SITE PLAN
BRIDGE NO. HAM-75-XXXX
WESTERN HILLS VIADUCT OVER IR-75

REVIEW COMPL

PROJECT ID	
114161	
SUBSET 1	TOTAL 7
SHEET P.457	TOTAL 463

HAM-75-1.95

WHV PROJECT CONSTRUCTION ITEMS

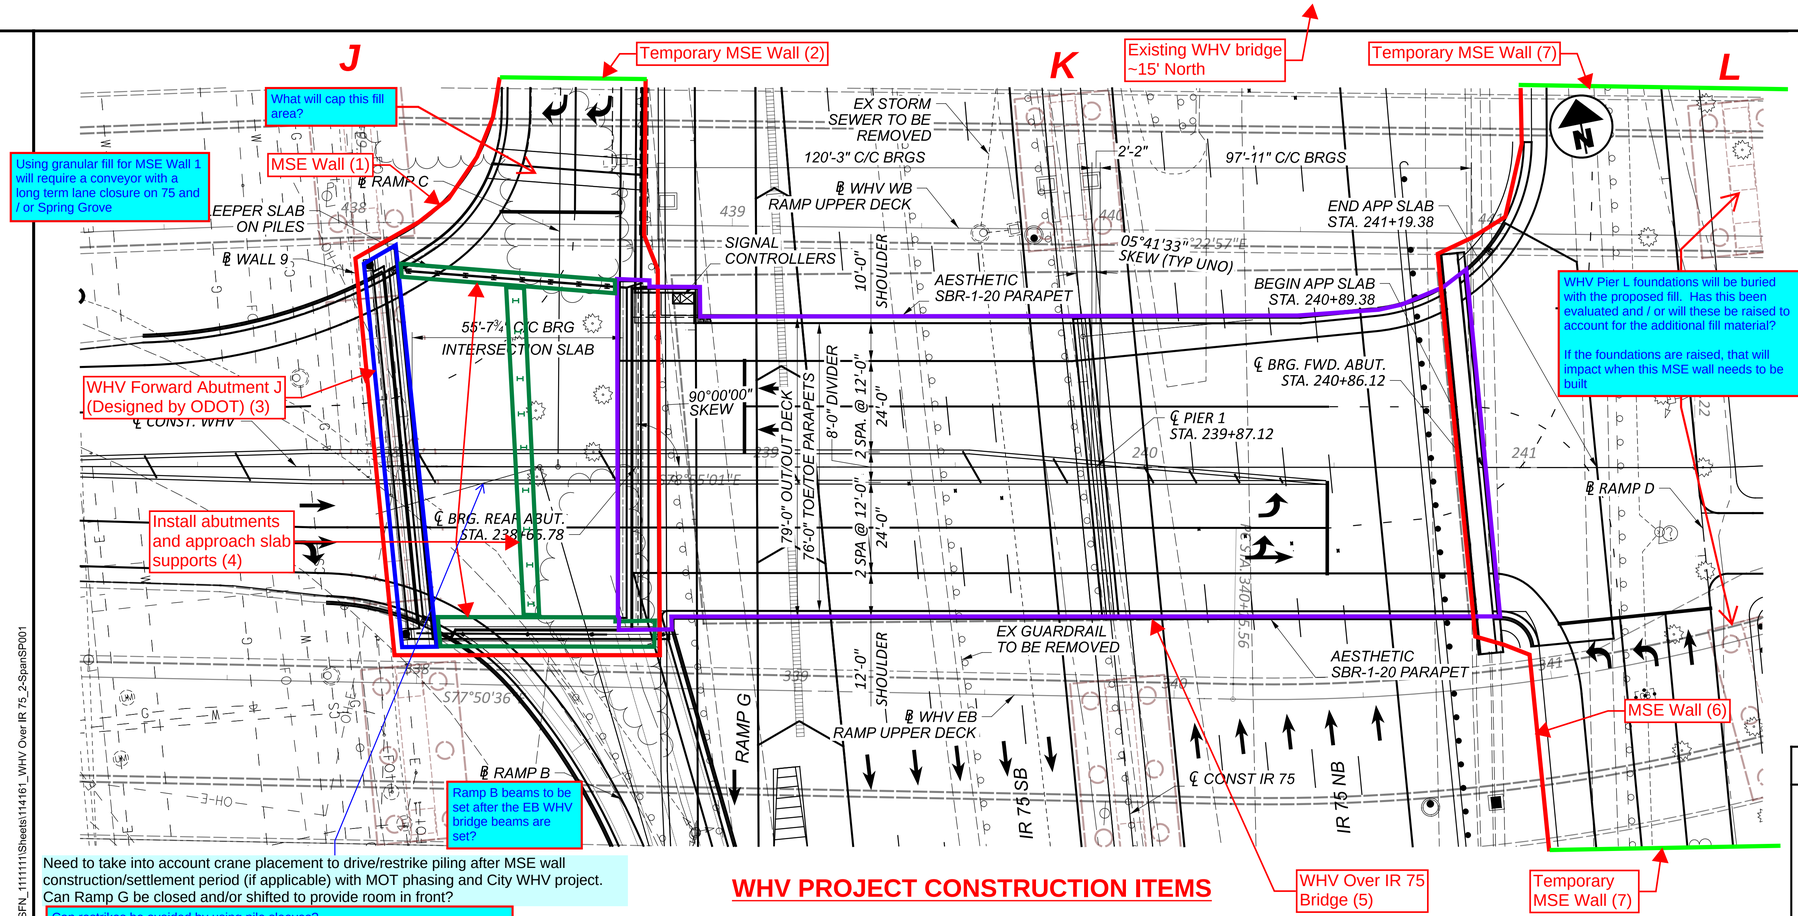
Need to take into account crane placement to drive/restrike piling after MSE wall construction/settlement period (if applicable) with MOT phasing and City WHV project.
Can Ramp G be closed and/or shifted to provide room in front?

Can restrikes be avoided by using pile sleeves?
Has the impact of MSE Wall 1 fill been evaluated with the TYL Pier J design?
- Is the use of foam blocks allowable to reduce the load?

PROFILE ALONG ℄ WHV

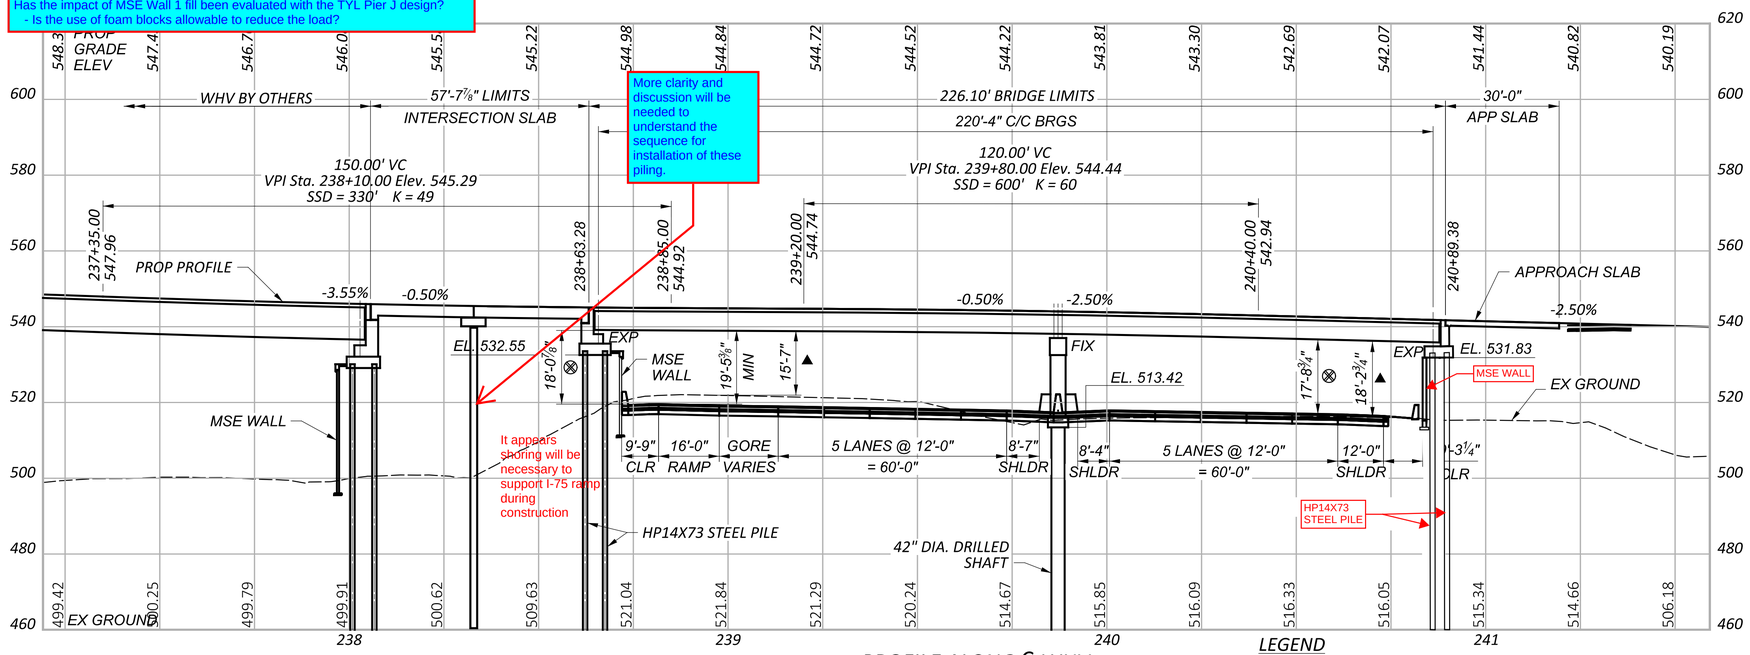
More clarity and discussion will be needed to understand the sequence for installation of these piling.
